Property Survey Notes on the Legionella Risk Assessment of:

Name: Tarporley Community Centre

**Address: High Street
Tarporley
CW6 0AY**

Report Date: 08/08/18

Photo 4 – Dead End Pipe Work Located Above the Ground Floor Main Hall Stage

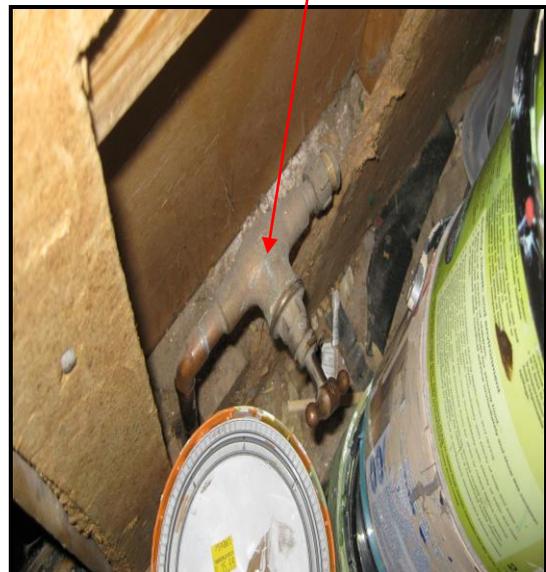
| RAR / Survey Results Reference | Comments and Action Required |
|--------------------------------|---|
| Medium | <p>There is a redundant or dead end pipe work located above the Ground Floor Main Hall Stage (see photo 4). Dead end pipe work (DEP) and or units should Always be removed when identified.</p> |
